**ADDENDUM NO.04 TO THE BIDDING DOCUMENTS**

**Package- 2 – E&M Works- Turbines, Generators, Electrical System, Switchyard  
and Power Evacuation – (Rebidding)**

**GABRAL KALAM HYDROPOWER PROJECT**

CONTRACT NO: PK-PEDO-370110-CW-RFB

- i. 12kV Single Line (SLD) for weir site      **(Drawing bearing No. GK-COB-ELC-004-01)**

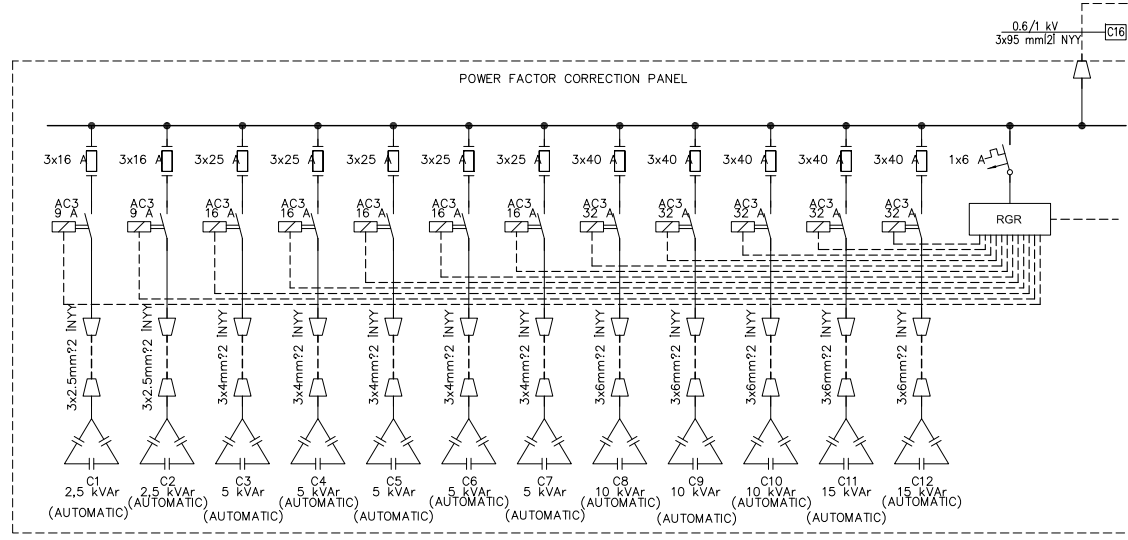
S#	Reference & Subject	RFB Requirement	Amendment through Addendum-04
5	<b>PART 2- EMPLOYER'S REQUIREMENTS</b>  Section VII (d) – Tender Drawings	-	12kV Single Line (SLD) for weir site is added to the Tender Drawings bearing the <b>Drawing No. GK-COB-ELC-004-01</b> , which is attached as Annex-I to this Addendum.
